WESTGATE VILLAGE 2ND ADDITION

RE: S/D 97-82- One-Step Final Plat of WESTGATE VILLAGE 2ND ADDITION

STAFF REPORT

CASE NUMBER: S/D 97-82 - WESTGATE VILLAGE 2ND ADDITION

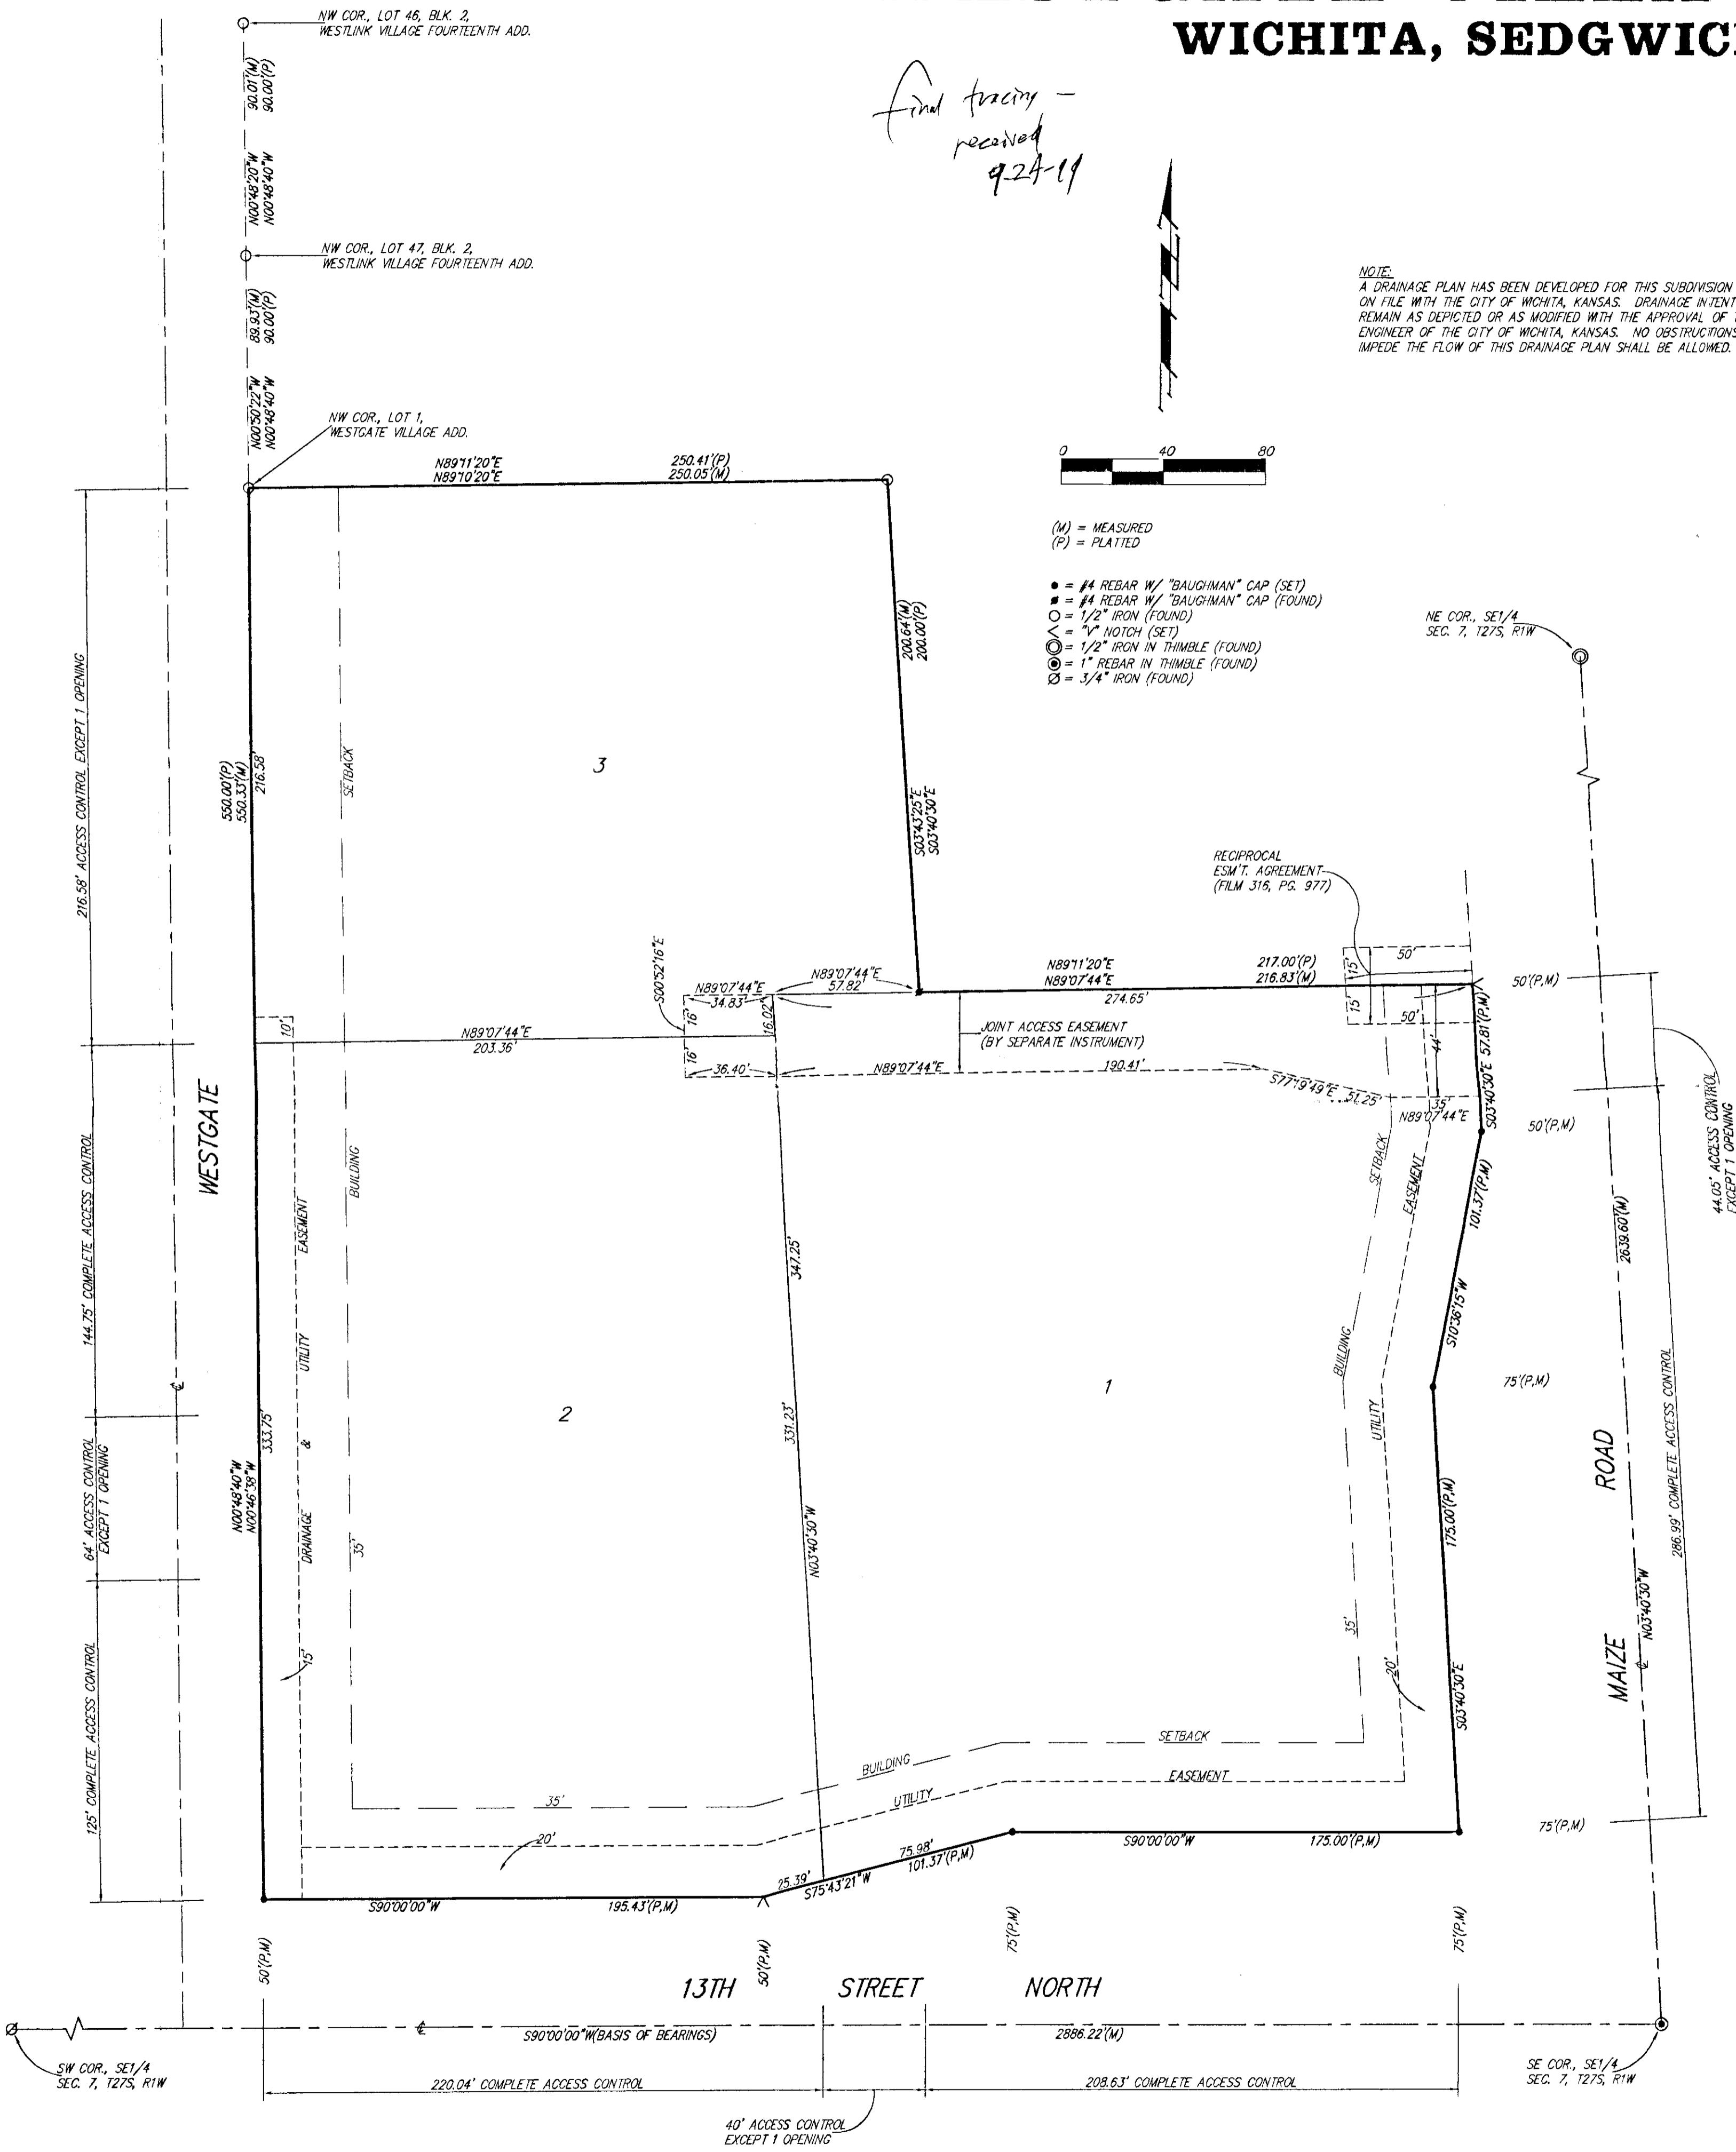
- C. City Engineering needs to comment on the status of the applicant's drainage plan. A cross-lot drainage agreement is needed. A drainage guarantee is required.

- D ✓ Traffic Engineering needs to comment on the proposed access controls. The Subdivision regulations encourage shared access points for multiple lot commercial sites along arterials, and the plat denotes a joint access along Maize Road between the plat and the plat zoned LC, Limited Commercial to the north. Another opening is proposed along Maize Road, and two openings proposed along 13th St. North. The applicant shall guarantee the closure of any driveway openings being located in areas of complete access control. Traffic Engineering requires 150 feet of complete access control along Maize Road from the intersection. Lot 2 shall have complete access control along 13th St. North. The opening along 13th St. North is limited to right turns only
If located within 250 feet of the intersection; otherwise full turns are permitted.

- E. Traffic Engineering shall comment on any improvements required for perimeter streets. *Traffic Engineering has required a right turn lane for westbound 13th St. North and for Maize Road.*

- F. The proposed joint access easement will need to be established by separate instrument. Initial construction responsibilities and future maintenance of the driveway within the easement should be addressed by the text of the instrument.

- G. The plat's text shall include language that a drainage plan has been developed for the plat and that all drainage easements, rights-of-way, or reserves shall remain at established grades or as modified with the approval of the applicable City or County Engineer, and unobstructed to allow for the conveyance of stormwater.

- I. The applicant's engineer is advised that the Register of Deeds is requiring the name(s) of the notary public, who acknowledges the signatures on this plat, to be printed beneath the notary's signature.

NOTE:
A DRAINAGE PLAN HAS BEEN DEVELOPED FOR THIS SUBDIVISION AND IS ON FILE WITH THE CITY OF WICHITA, KANSAS. DRAINAGE INTENT SHALL REMAIN AS DEPICTED OR AS MODIFIED WITH THE APPROVAL OF THE CITY ENGINEER OF THE CITY OF WICHITA, KANSAS. NO OBSTRUCTIONS WHICH IMPEDE THE FLOW OF THIS DRAINAGE PLAN SHALL BE ALLOWED.
